**OHIO DEPARTMENT OF TRANSPORTATION**  
CENTRAL OFFICE, 1980 W. BROAD ST., COLUMBUS, OHIO 43216-0899

Re: 2010 First Quarter Revisions

Revisions have been made to the ODOT Bridge Design Manual, July 2007. These revisions shall be implemented on all Department projects with a Stage 2 plan submission date after January 15, 2010.

## Summary of Revisions to the July 2007 ODOT BDM

### 303.4.3 DRILLED SHAFTS

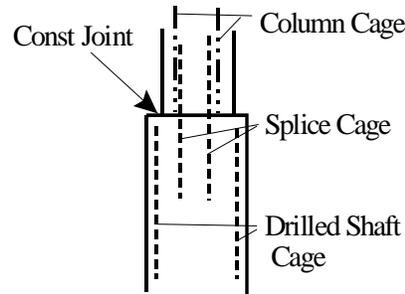
303.4.3	3-68	This revision addresses an exception ODOT has taken to the AASHTO LRFD Bridge Design Specification, Article 5.13.4.5.2 regarding clear spacing around longitudinal and lateral steel in drilled shafts.

The minimum clear distance between longitudinal and lateral reinforcement shall not be less than 5 times the maximum aggregate size. Where heavy reinforcement is required, consideration may be given to an inner and outer reinforcing cage.
